Appln No. 10/729,256
Amdt date March 11, 2005
Notice of Allowance mailed December 15, 2004

Amendments to the Drawings:

REMARKS/ARGUMENTS

FIG. 5

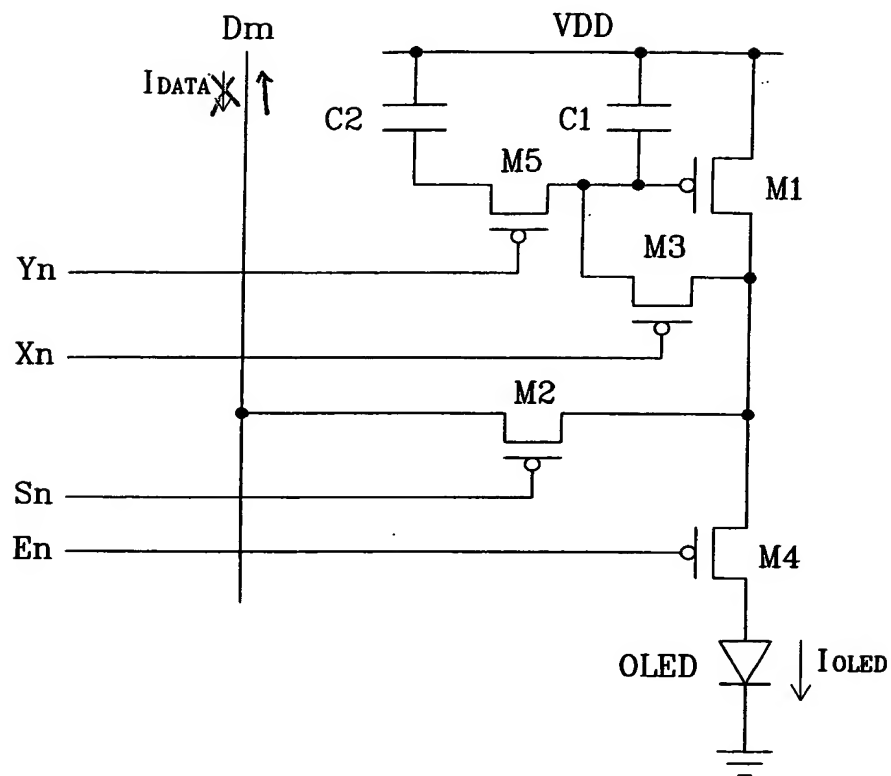
The attached sheets of drawings includes changes to FIGs. 5, 7, 9, 11 and 13-15. These sheets, which include FIGs. 5-16, replace the original sheets including FIGs. 5-16.

Amendments have been made to the specification and the drawings to correct certain minor clerical errors. No new matter is being added since the corrections would be obvious to those skilled in the art from the circuit diagrams and the timing diagrams in the drawings, and the description thereof in the specification.
